TECH BULLETIN

110
1/11

SUBJECT: Seal case modification

Models: 3CP1120, 3CP1120.3400, 3CP1130, 3CP1130.3400, 3CP1140, 3CP1140.3400

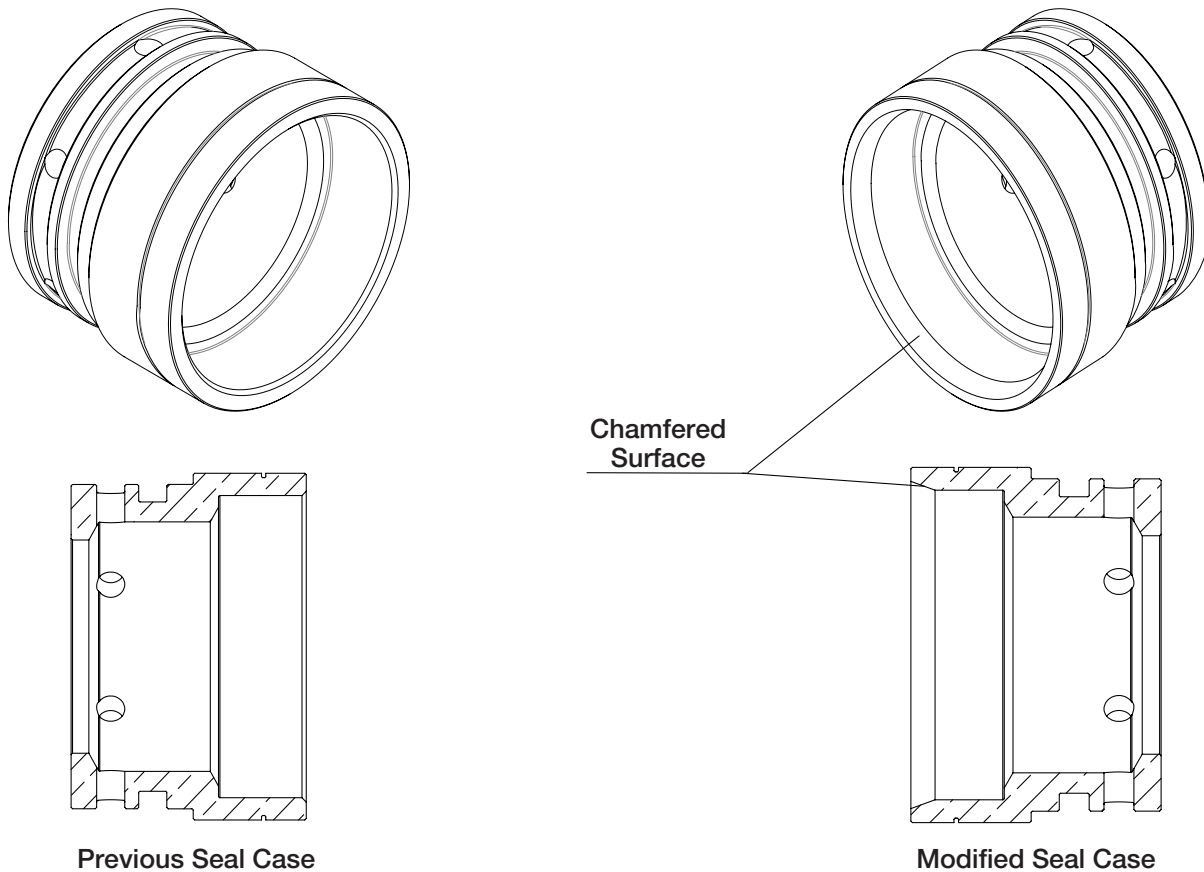
The seal case has been improved by increasing the chamfered surface on the large inside diameter of the seal case. This modification to the seal case will ensure proper installation and eliminate potential damage when installing all types of Lo-Pressure seals.

Seal case 49426 used in conjunction with our special ST Lo-Pressure seal has been obsoleted and has been replaced with the modified seal case part number 46625. If retrofitting a pump with a suffix part number (.3400) prior to April 2010, use seal kit 76526 that includes seal case 46625. After April 2010, all pump models as listed above will include this modified seal case.

This change will be phased in starting with April 2010 production.
